FIG. 2

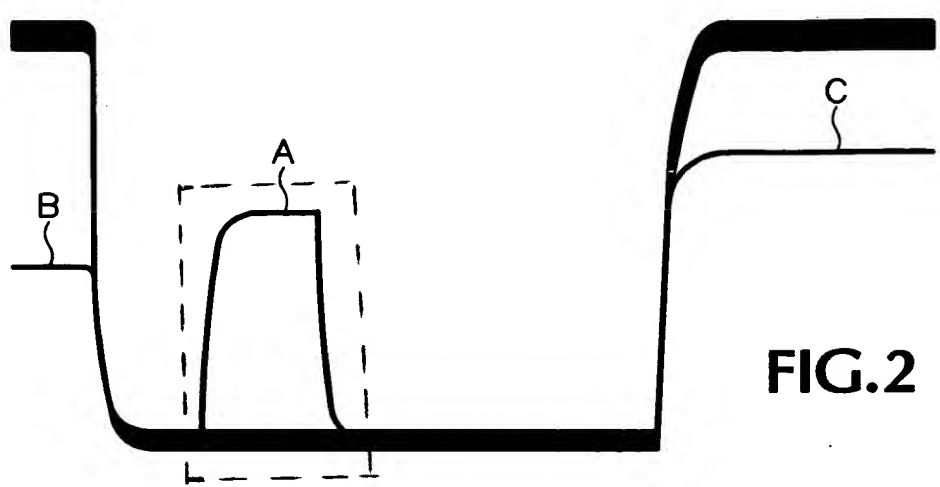
Subject to the Examiner's approval, FIGURE 2 has been amended by adding a box, as shown in the attached drawing. The box is described in the specification on page 5, line 14. No new subject matter has been added.
